Office Action Summary	Application No. 10/579,284	Applicant(s) SCHLEGL ET AL.	
	Examiner MARINA TIETJEN	Art Unit 3753

DETAILED ACTION

5. Claims 11-17 and 19-21 are rejected under 35 U.S.C. 103(a) as being unpatentable over Meintschel (DE 10204122) in view of Keck et al. (U.S. Pat. No. 5,054,195).

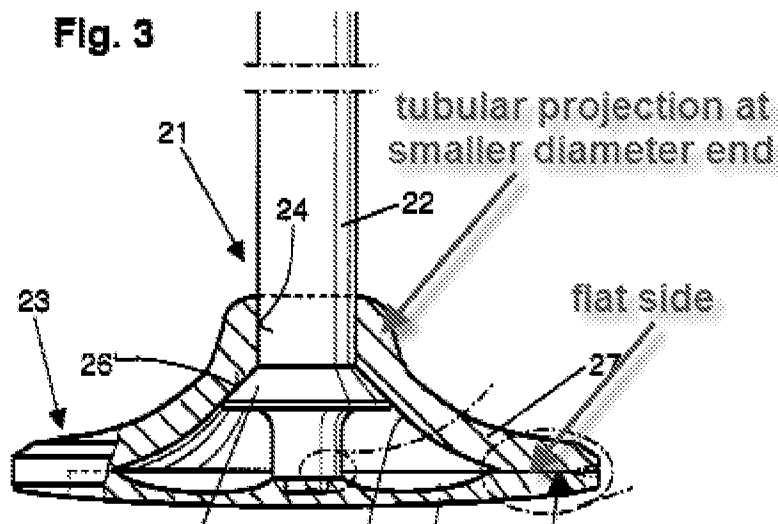
Meintschel discloses a lightweight valve (fig. 3) comprising:

a valve stem (22, fig. 3); a hollow valve cone (27) with a hollow space having an end of greater diameter; and a valve disk (28) closing the hollow space on one side and having a flat side (see labeled fig. 3 below) facing the valve cone (27);

the valve stem (22) being connected to a stem connection element (24) formed on or fastened to the valve disk (28);

a valve cone support (26) located at a distance from the valve disk (28) and provided in the hollow space, the valve cone support (26) being located on the stem connection element (24) and projecting above the flat side (labeled fig. 3 above);

wherein the valve cone support (26) includes at least one supporting surface (26') bearingly contacting an inner wall region of the valve cone (27);

wherein a contour of the supporting surface (26') complements the inner wall region;

wherein the valve cone support (26) is formed by a thickening on the stem connection element (24);

wherein the valve cone (27) is of disk-spring-shaped design (cone has concave shaped surface like a disk-spring);

wherein the valve cone (27) has, at a smaller diameter end, a tubular projection (see labeled fig. 3 above) for guiding through the valve stem (22) or the stem connection element (24);

wherein the valve cone support (26) forms a centering or supporting seat for the valve cone (27); and

However, Meintschel does not disclose the valve disk having a recess serving as a centering or supporting seat for receiving the end of greater diameter of the valve cone, the valve disk including a step extending upward from the flat side of the valve disk so as to define an inner circumference of the recess, the step supporting an inner circumference of the end of greater diameter of the valve cone; wherein the valve disk includes a frusto-conical portion that forms an outer bearing surface of the recess and supports an end face of the end of greater diameter of the valve cone; and wherein a

cone angle of the frusto-conical portion of the valve disk is the same as a cone angle of the valve cone at the end of greater diameter.

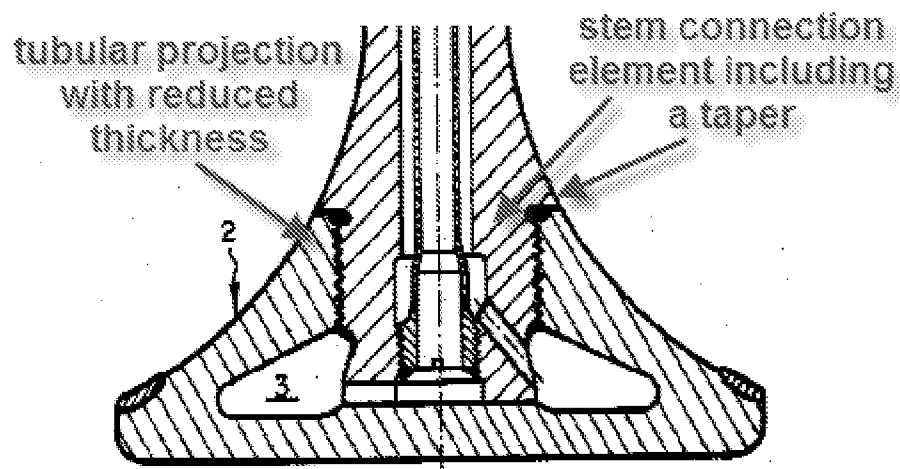
However, Meintschel does not disclose the tubular projection having a reduced thickness in relation to a remainder of the cone so that the tubular projection nestles

against the stem connection element; and wherein the stem connection element includes a taper receiving the tubular projection such that a continuous transition is formed between the tubular projection and the stem connection element.

Ysberg teaches a cone with a tubular projection (see labeled fig. below) having a reduced thickness in relation to a remainder of the cone (2) so that the tubular projection nestles against the stem connection element (see labeled fig. below); and wherein the stem connection element includes a taper (see labeled fig. below) receiving the tubular projection, for the purpose of providing a connection means which provide a smooth transition between the valve stem and the valve cone.

It would have been obvious to one having ordinary skill in the art at the time the invention was made to modify Meintschel's valve, such that the tubular projection is a reduced thickness in relation to a remainder of the cone so that the tubular projection nestles against the stem connection element; and wherein the stem connection element includes a taper receiving the tubular projection, as taught by Ysberg, for the purpose of

providing a connection means which provide a smooth transition between the valve stem and the valve cone.
